ADMINISTRATIVE

APPROVALS

April 02, 2025

1 PROPOSED ELECTRICAL SERVICE
SCALE: NTS

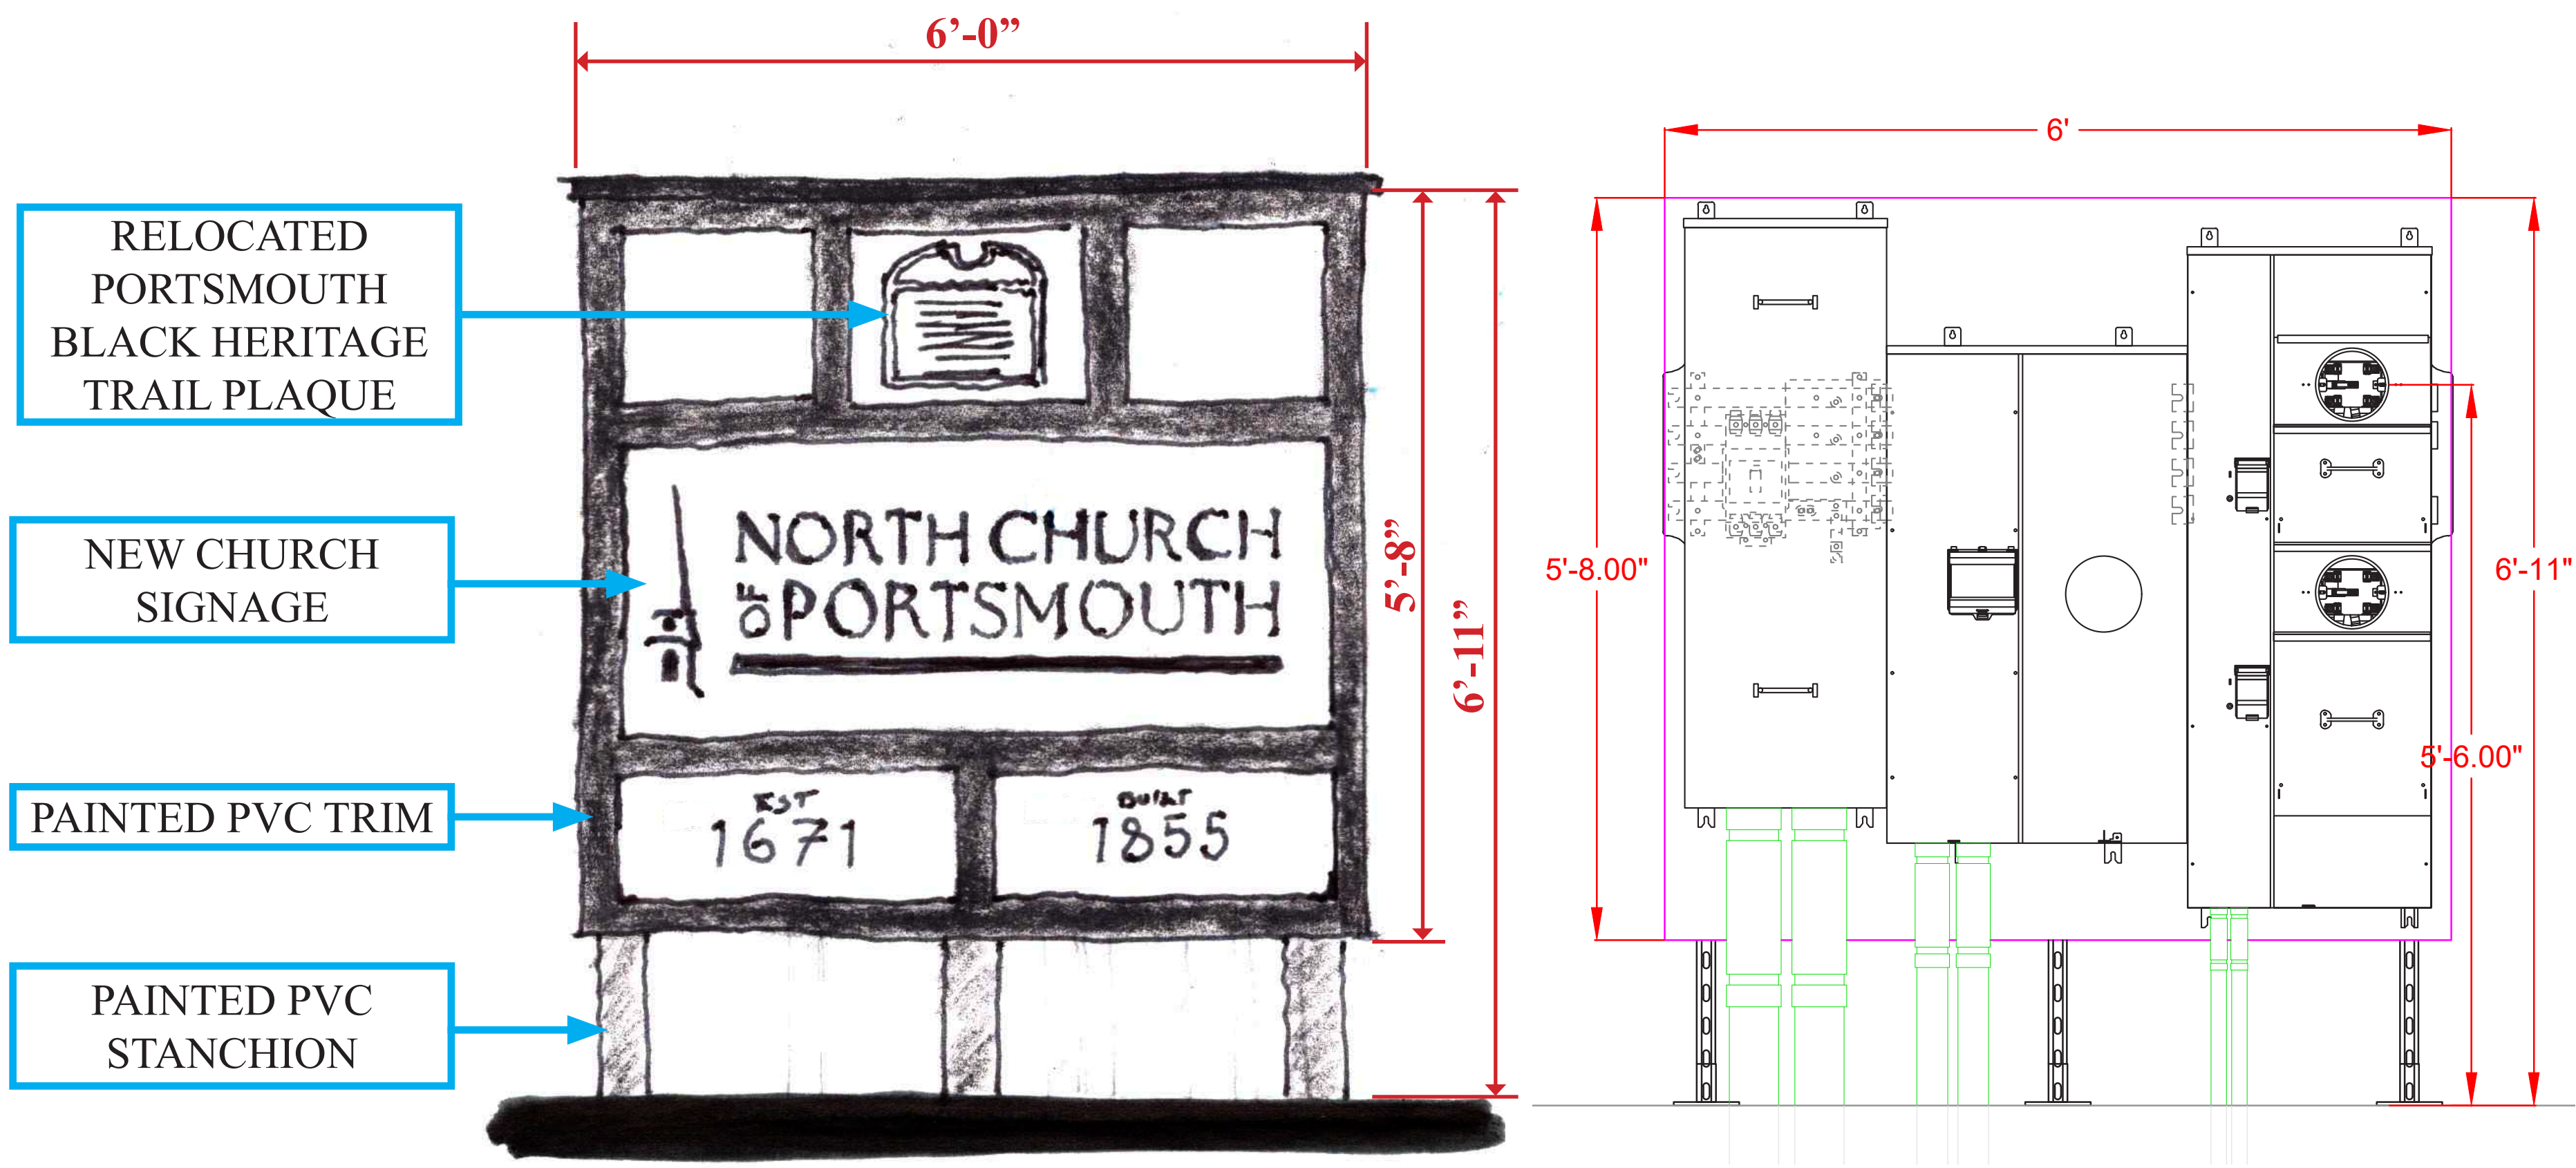
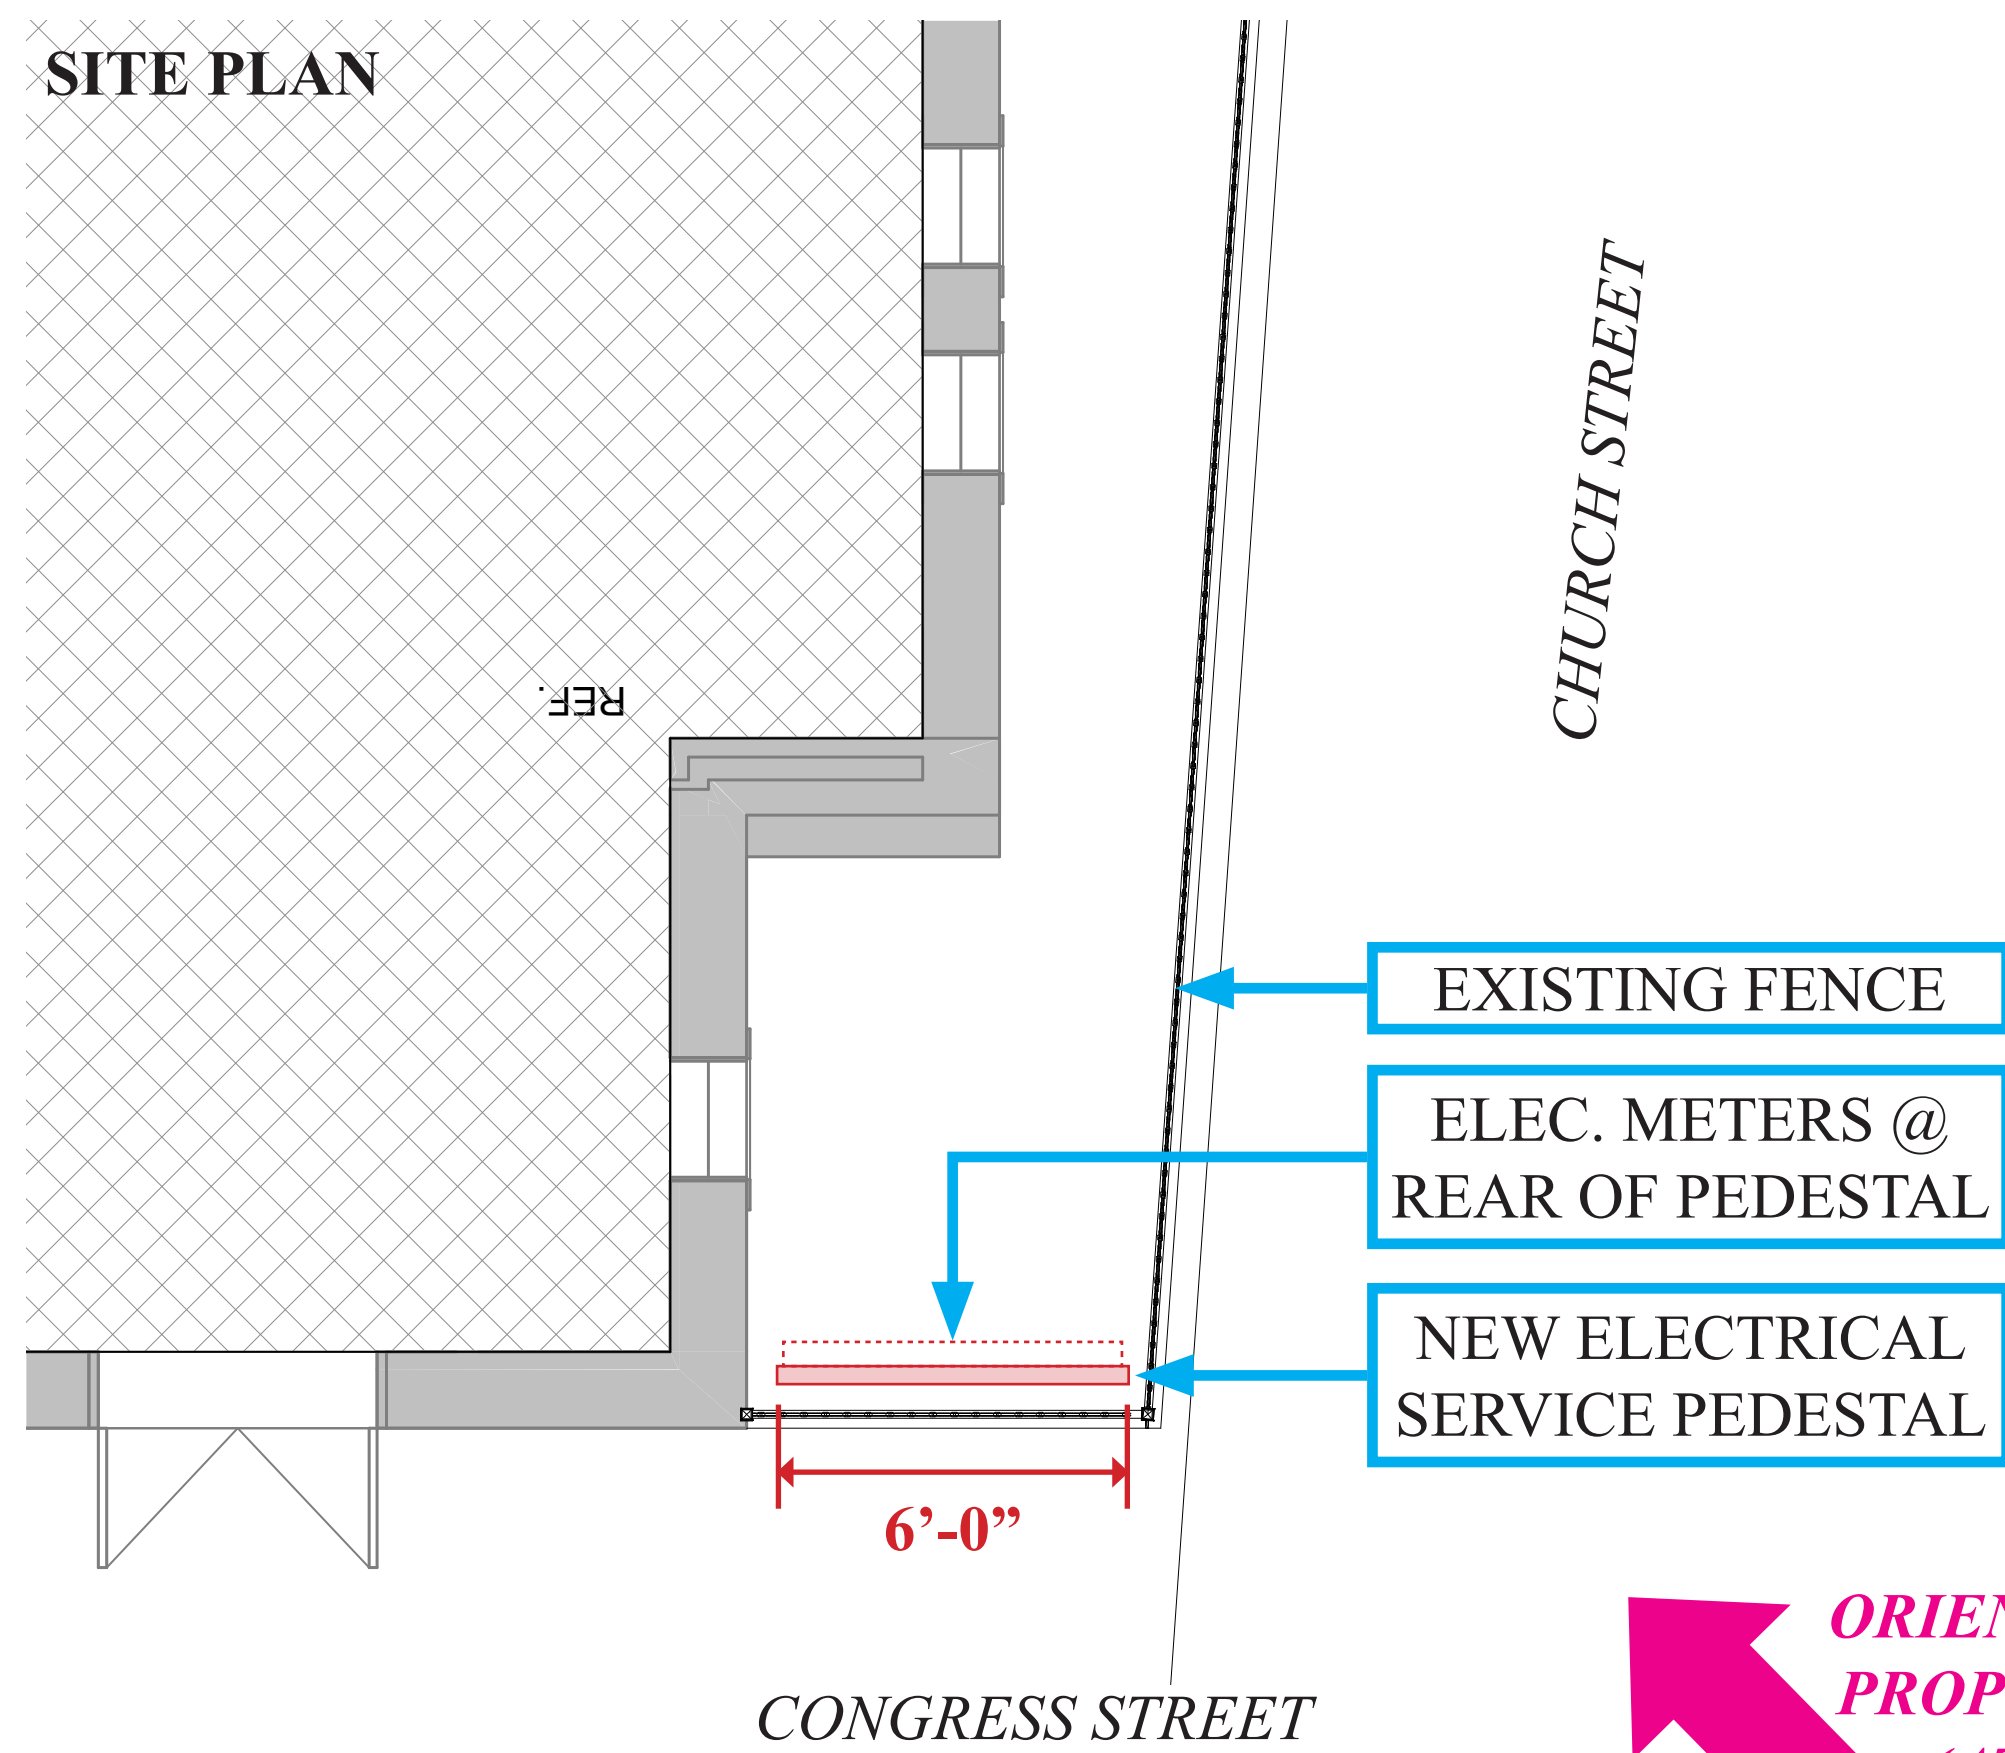
Background: The applicant is seeking approval for the removal of the electric meters on the building and move them to a free standing panel.

APPROXIMATE EXTENT OF
NECESSARY ELECTRICAL
METER UPGRADES:
 - OBSCURES WINDOW
 - CONFLICT W/ GAS LINE
 - TOO CLOSE TO GAS METER
 - REQUIRES ADDITIONAL
MOUNTING TO BUILDING

RIGHT SIDE ELEVATION
SCALE: 3/16" = 1'-0"

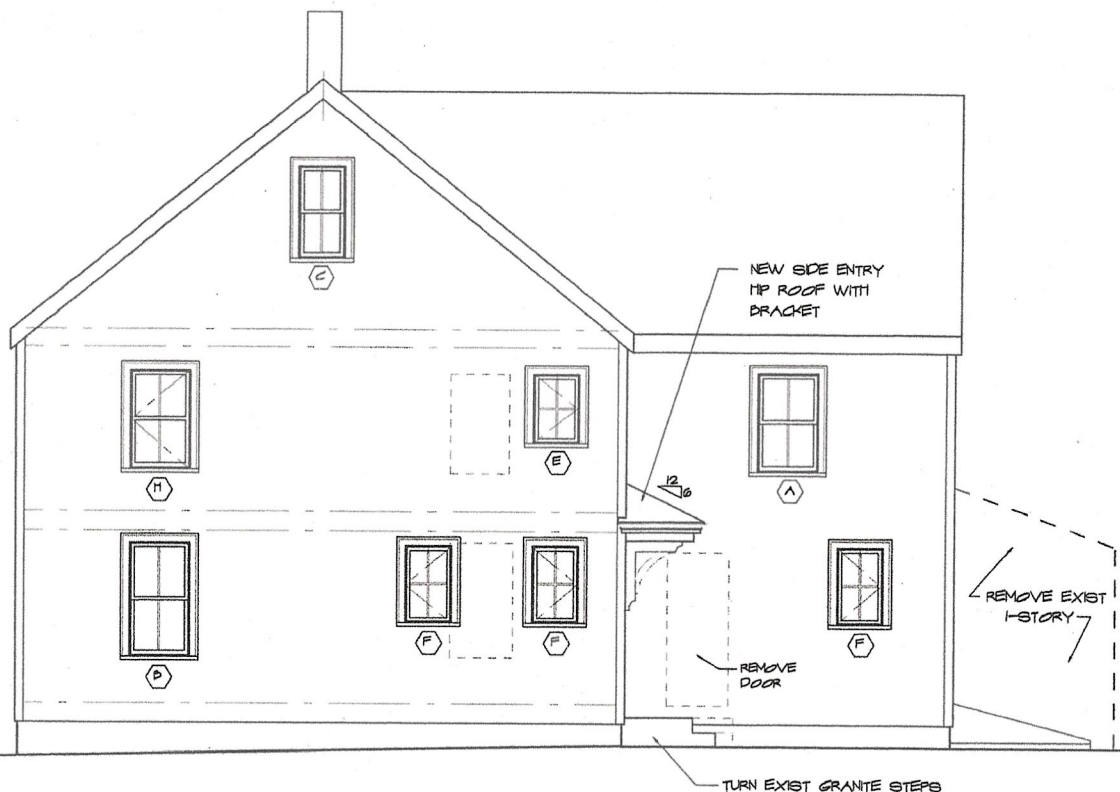
NOTE: REPLACE EXISTING ALUMINUM SIDING
WITH PREPRIMED ~~CEDAR~~ CEDAR CLAPBOARDS

LIFESPAN THIS SIDE

**H2.1 STATE STREET ELEVATION
111 STATE STREET**

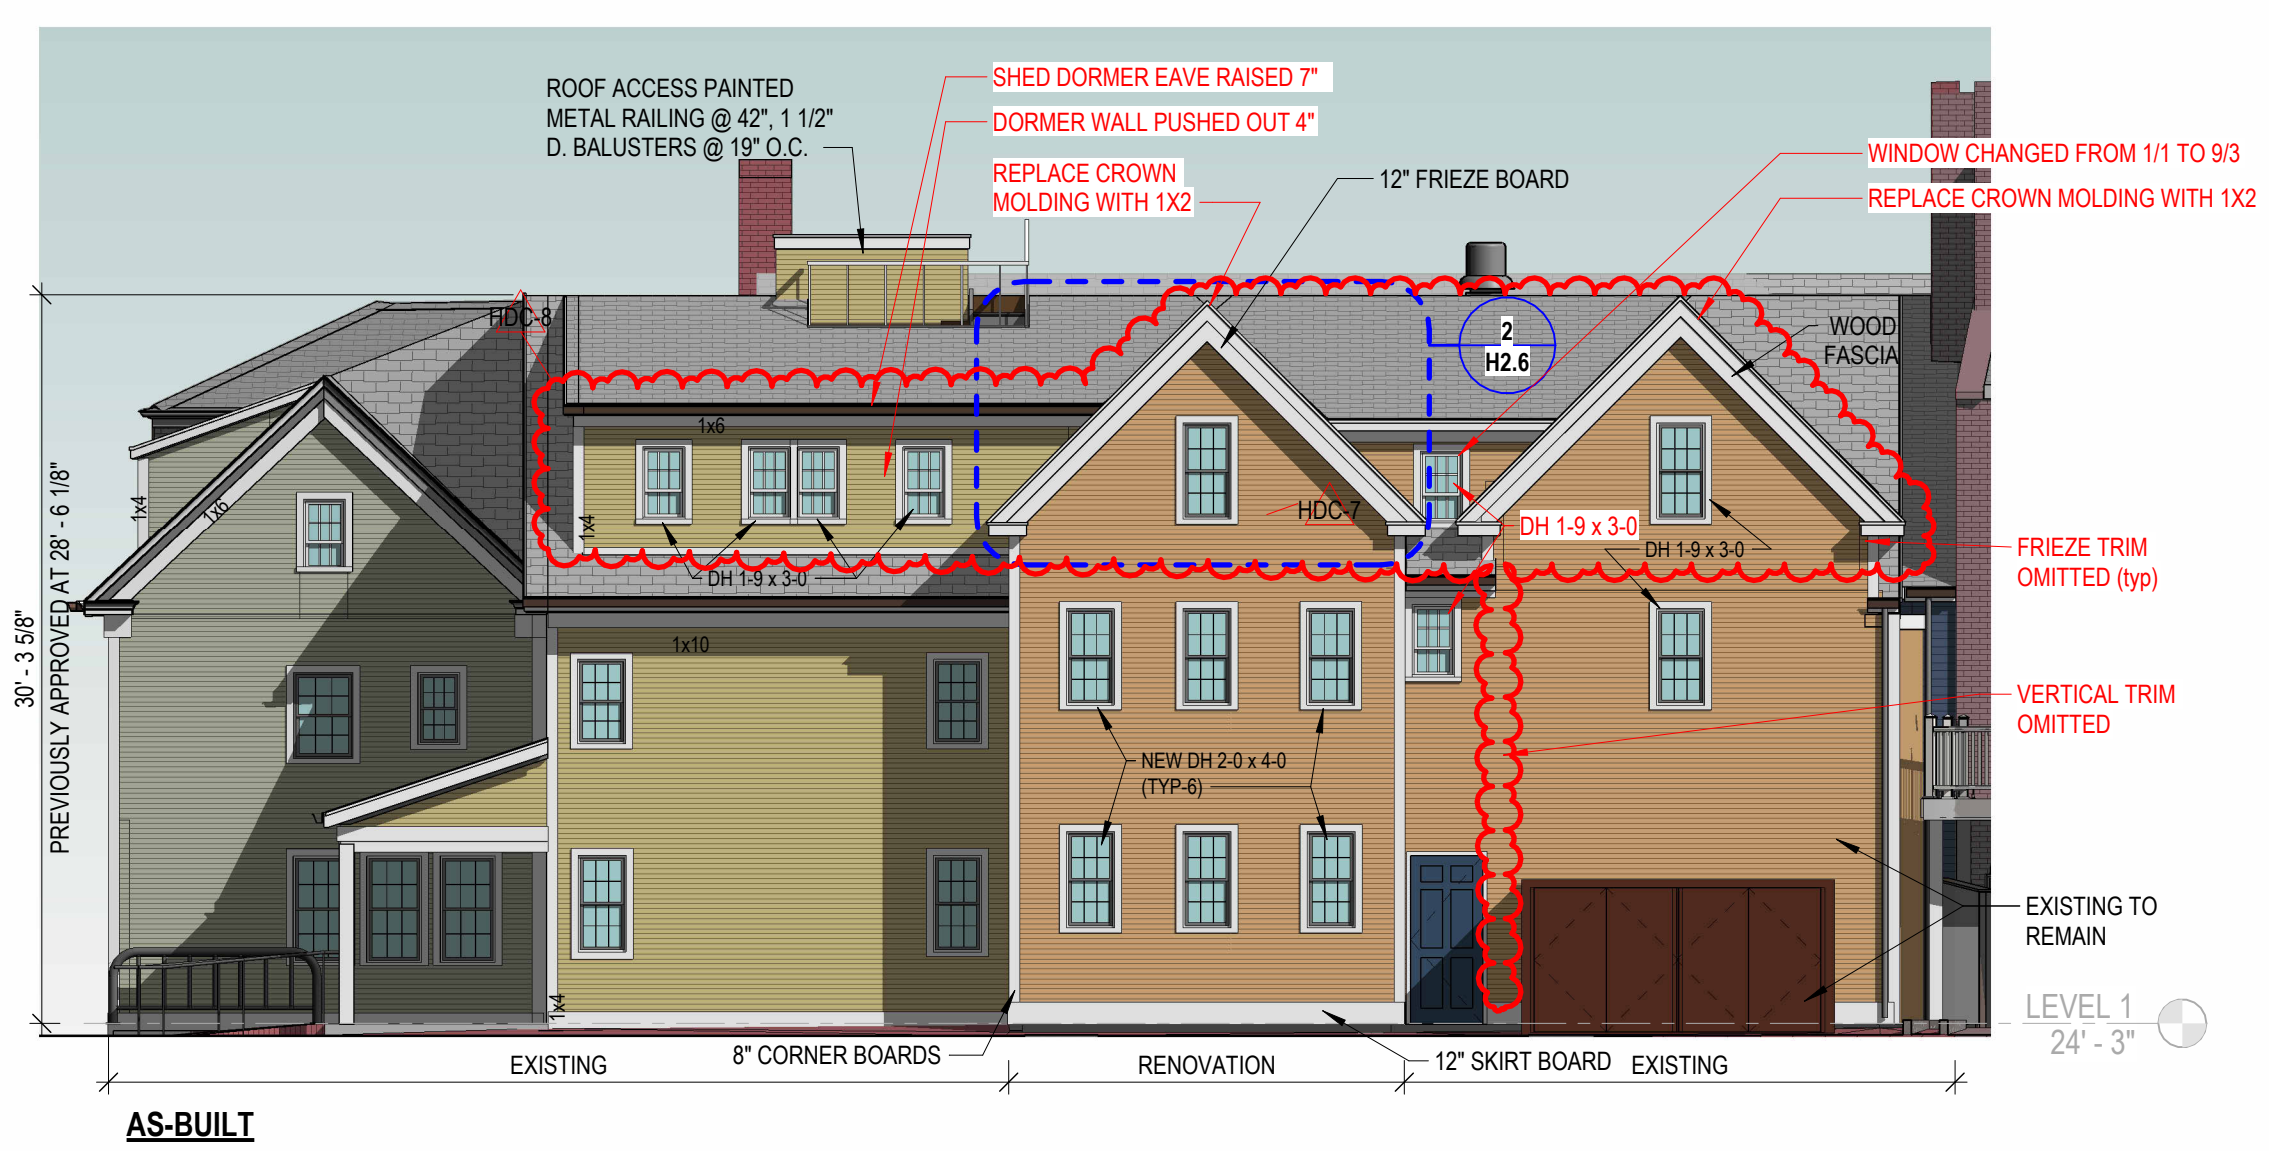
(CHANGED SIDELITES FROM WOOD PANEL TO GLASS)

1-PAIR OF 6'-6" WIDE SLIDERS WITH 16 LITES, INSTEAD OF 2 PAIRS OF 3' WIDE SLIDERS WITH 32 LITES.
